Service Bulletin

#SB1019

Issue Date:	**October 30, 2019**
Subject:	**SpectroLink upgrade to internal electronics board for improved robustness against voltage transients.**
Affected Product(s):	**SpectroLink Integration Box used with SX Series Searchlight Systems.**
Part Numbers impacted:	033537 033537-1
Serial Numbers impacted:	1 – 174
Compliance:	Mandatory
Compliance time:	6 months from date of this bulletin.

Figure 1: System Layout

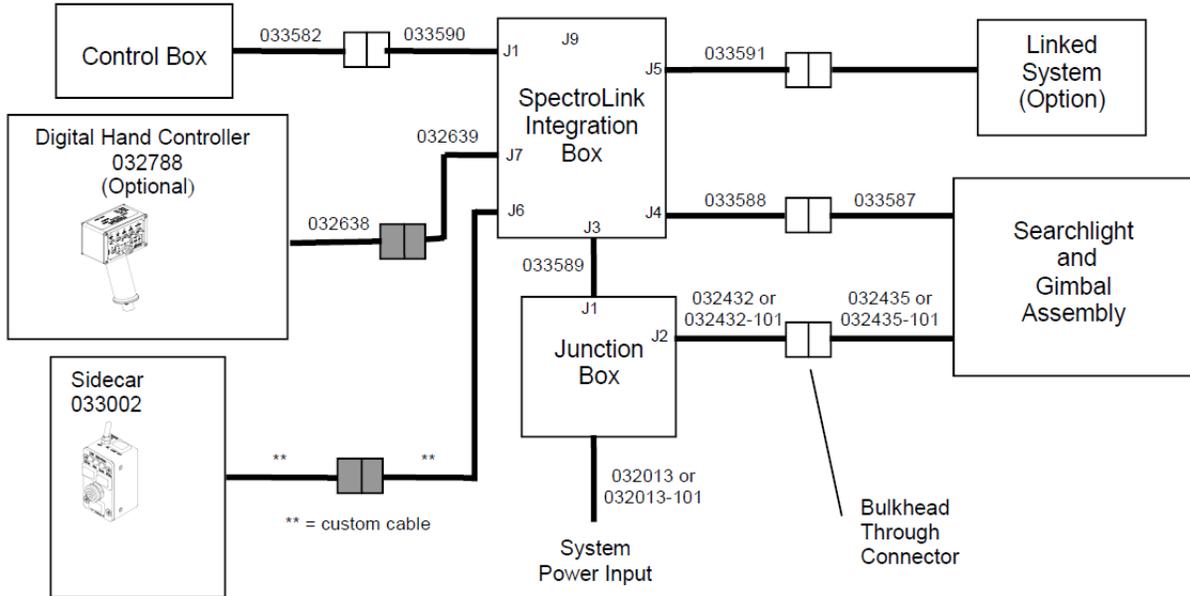
How to verify the serial number or manufacture date of your device.
1. Locate the SpectroLink Box on your aircraft by referring to your installation documentation package. If you do not have this data available, locate the searchlight system Junction Box (J-Box) and follow the cable harness that runs from the J-Box J1 connector to the SpectroLink Box J3 Connector, as shown in *figure 1*. The SpectroLink Box is sometimes located directly on top of the Junction Box, as shown in *figure 2*.
2. Locate the name plate on the SpectroLink Box, as noted in figure 3.
3. Note items identified in figure 3.
4. Contact Spectrolab Customer Service to verify if this Service Bulletin is applicable.
